Subject: Comments regarding NUREG-1437, Supplement 14
R. E. Ginna Nuclear Power Plant
Docket No. 50-244

ATTACHMENT A: RG&E COMMENTS ON NUREG-1437, SUPPLEMENT 14

ATTACHMENT B

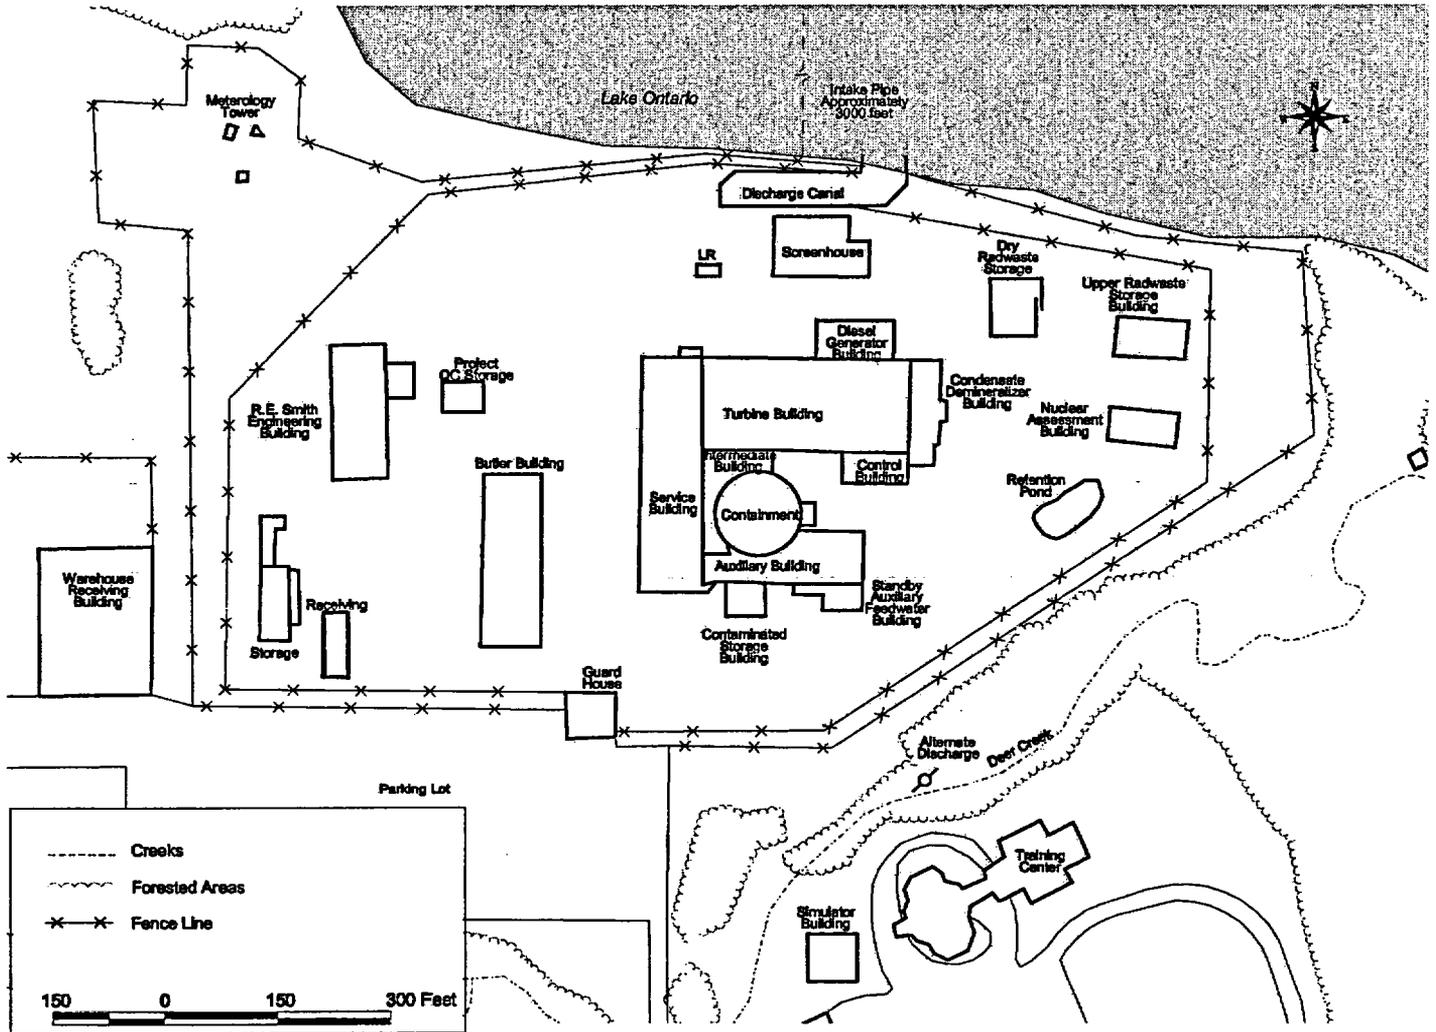
- Comment 1:** There is a typographical error on page 2-1, line 29. 0.9 km should be 2.4 km.
- Comment 2:** Minor changes should be made to Figure 2-3, as provided in Attachment B.

ATTACHMENT C

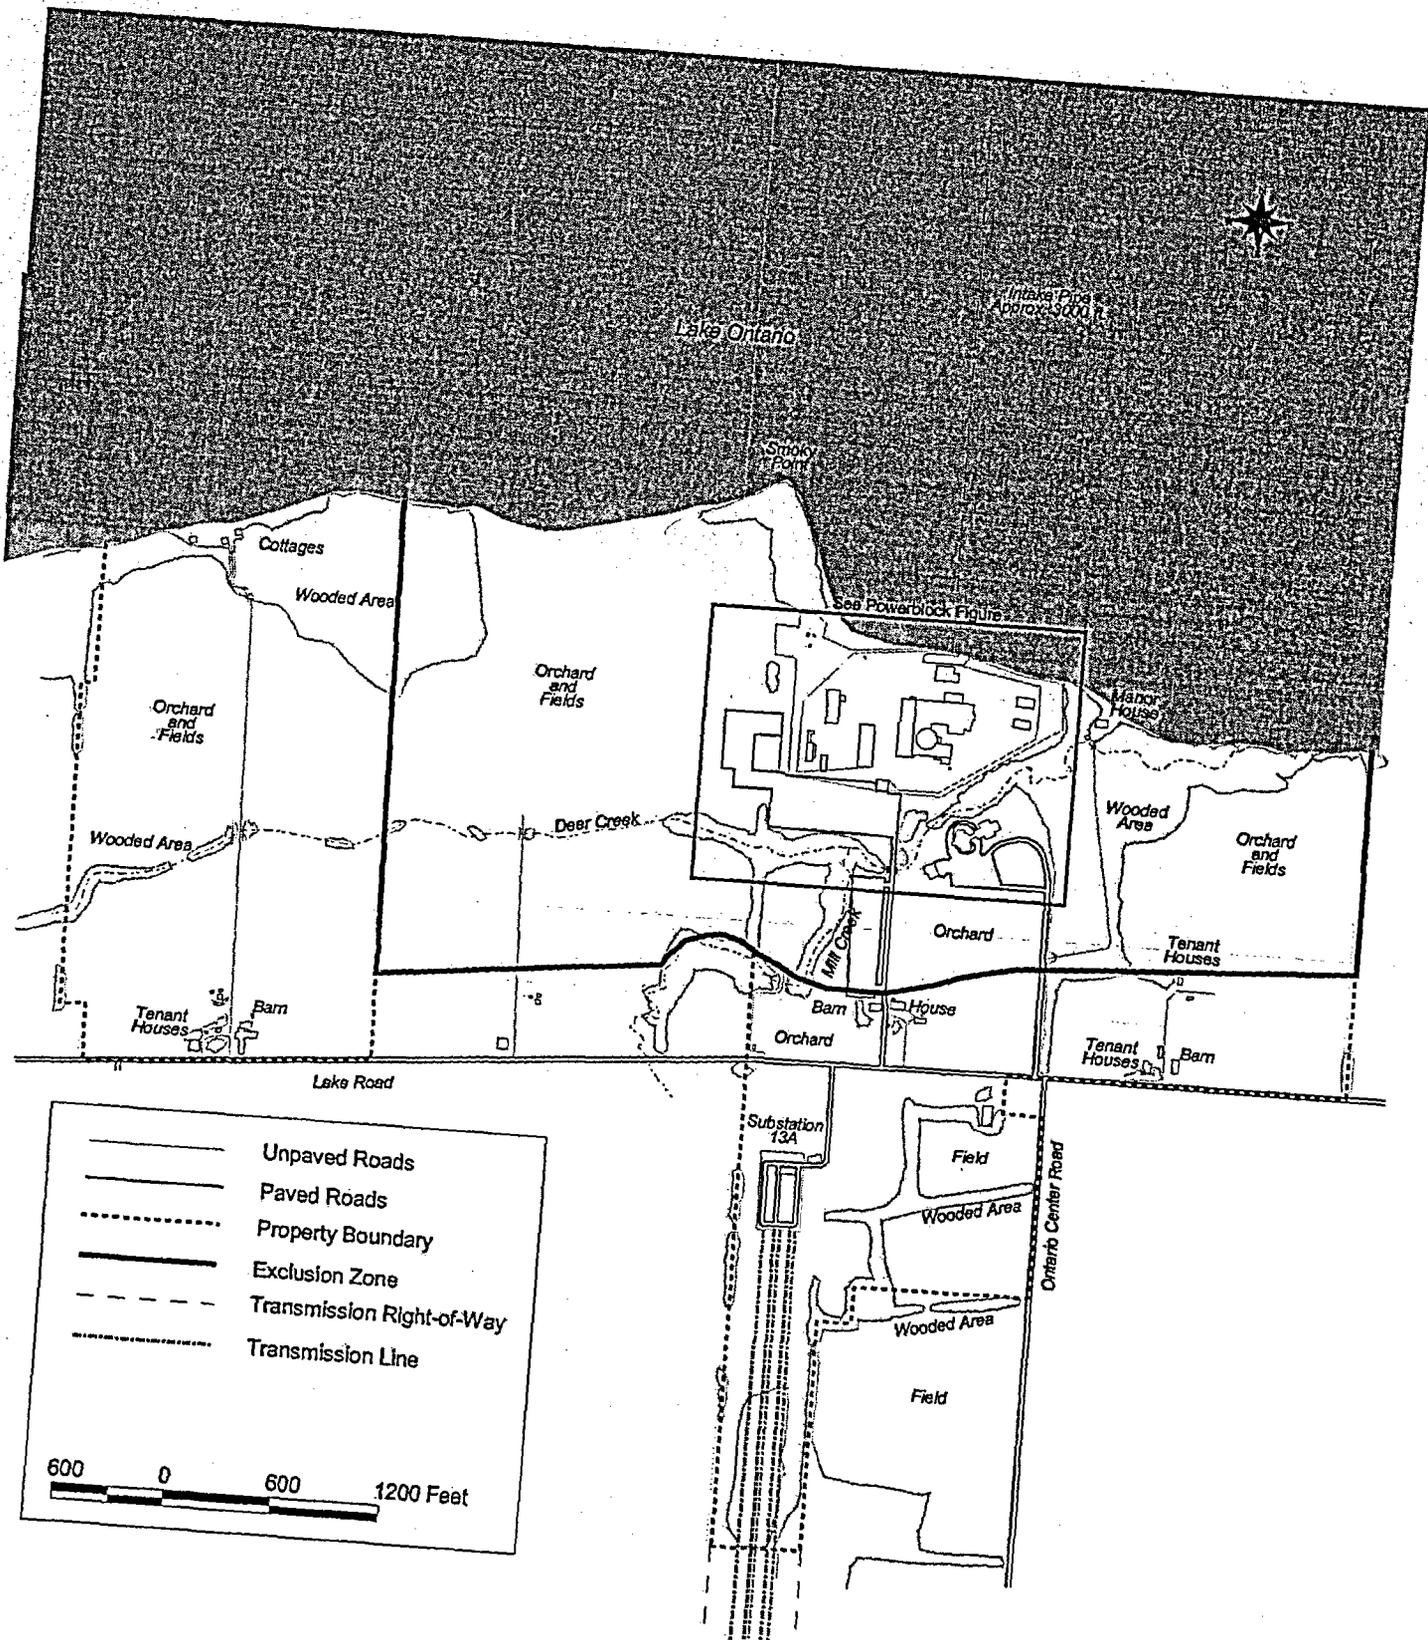
- Comment 3:** Minor changes should be made to Figure 2-4, as provided in Attachment C.
- Comment 4:** In Section 2.2, page 2-17, line 25-27, reference is made to a land transaction. This has not occurred; therefore, this sentence should be deleted.
